Attachment C: PJM Deliverability Testing Methods

Figure E-1 (Delmarva South)

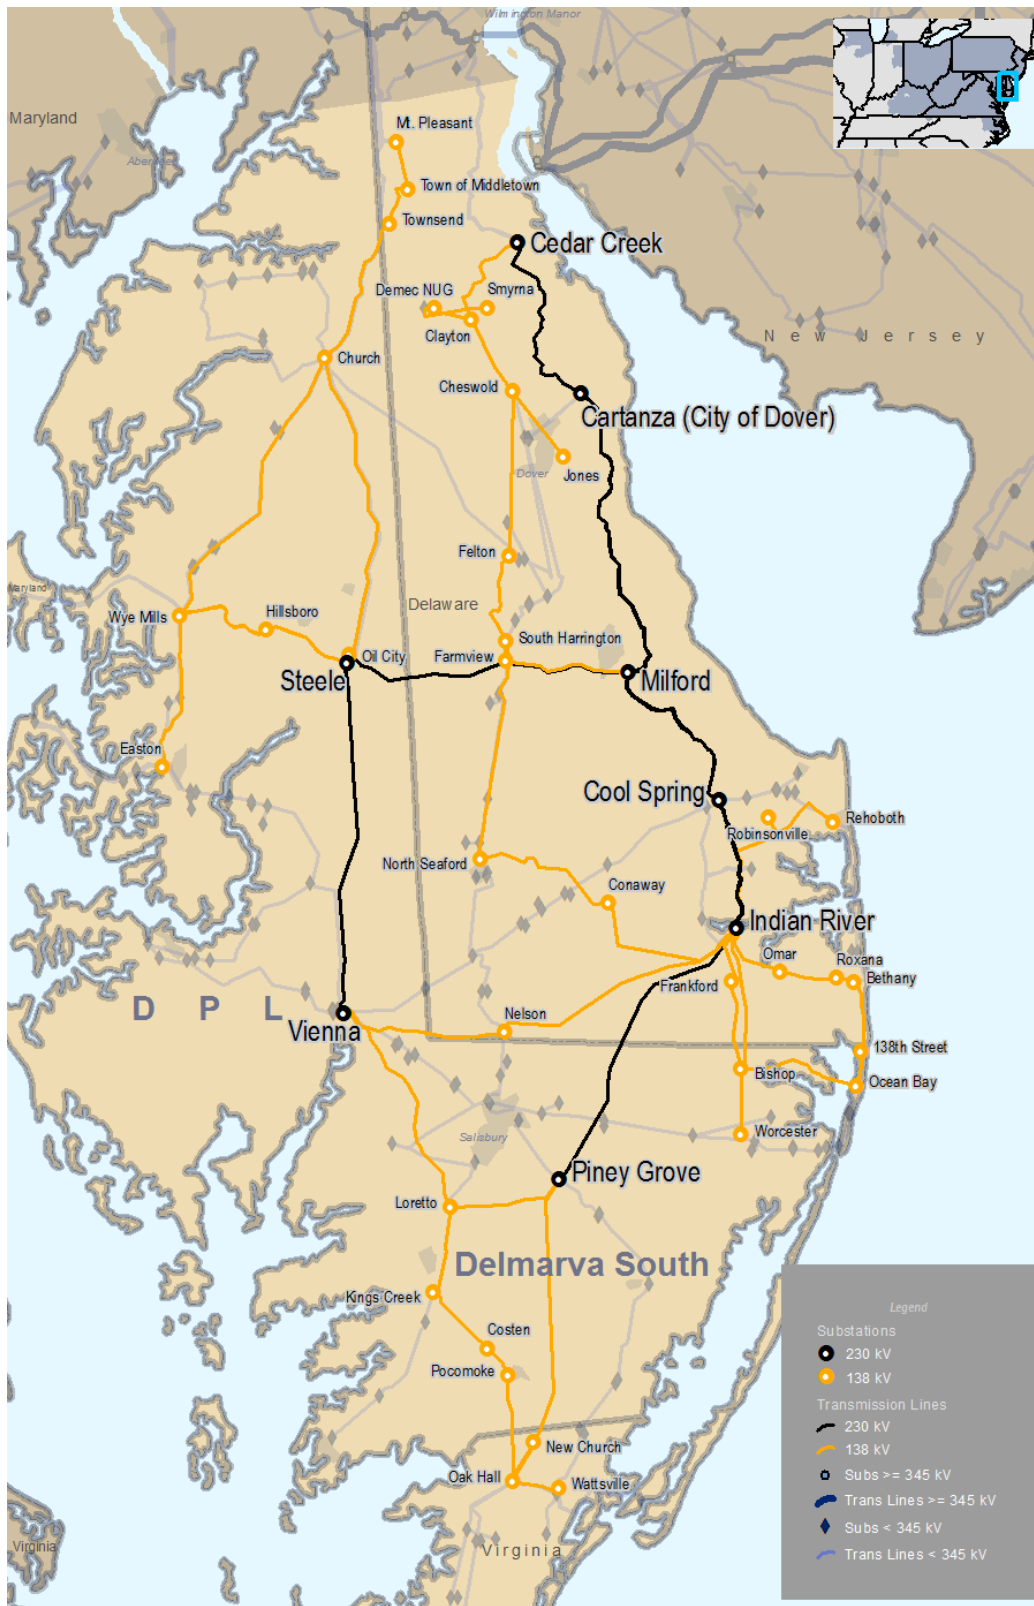
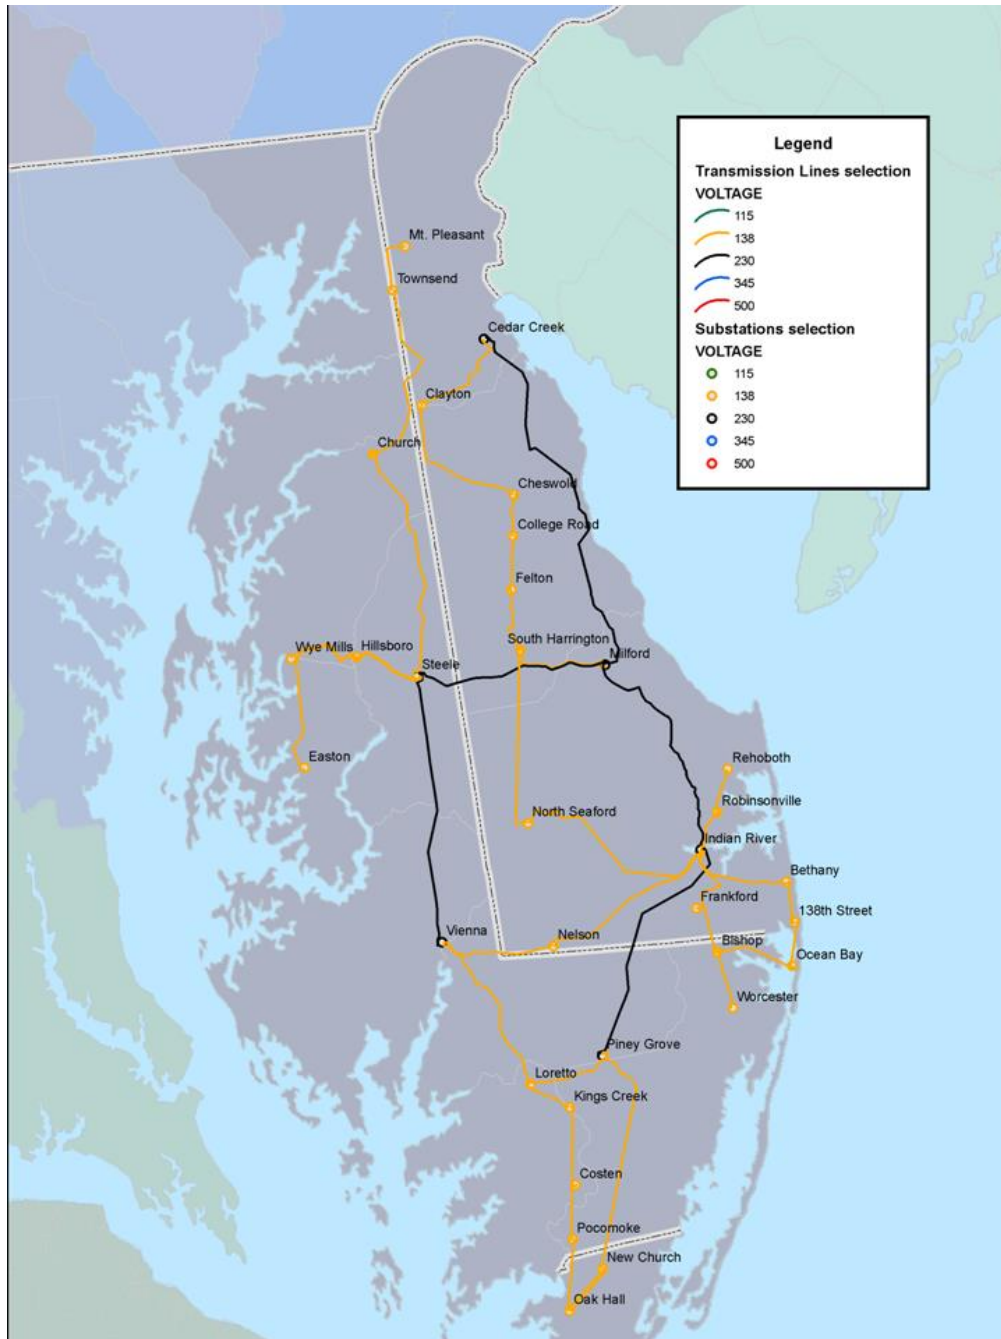
Delmarva South - All load and generation connected at 230 kV and below as defined in Figure E-1.

Figure E-2 (PSE&G North)

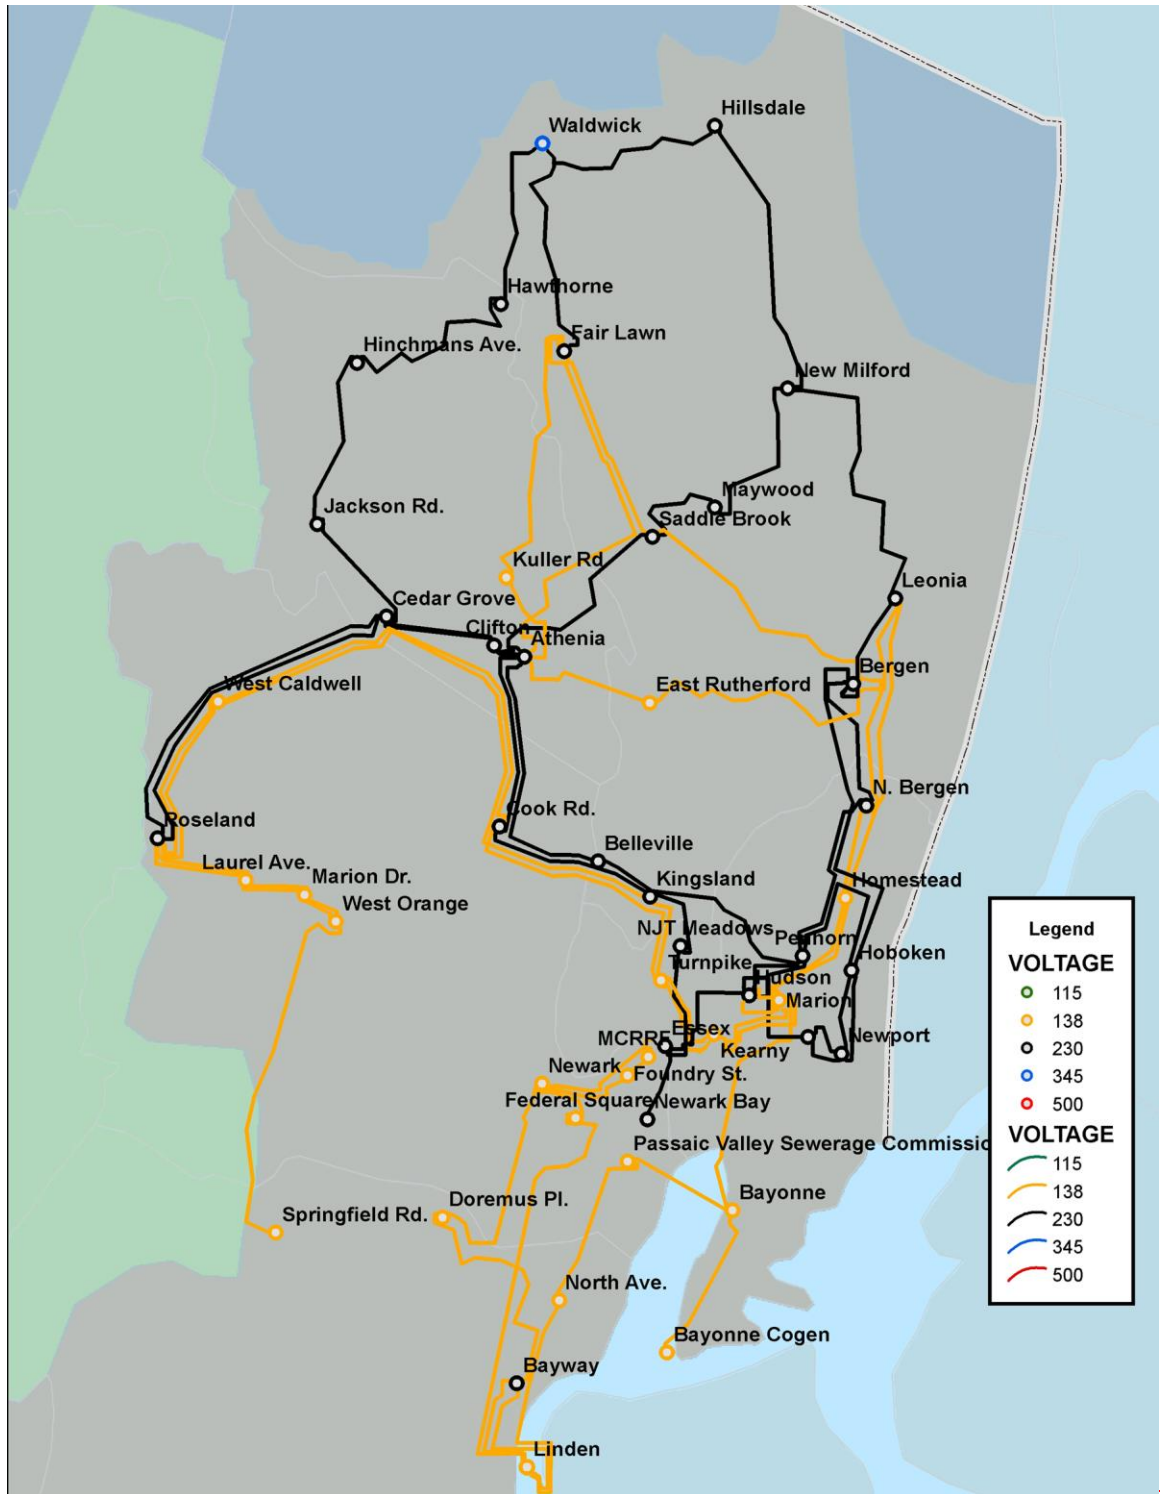
PSE&G North - All load and generation connected at ~~230-345~~ kV and below as defined in Figure E-2.
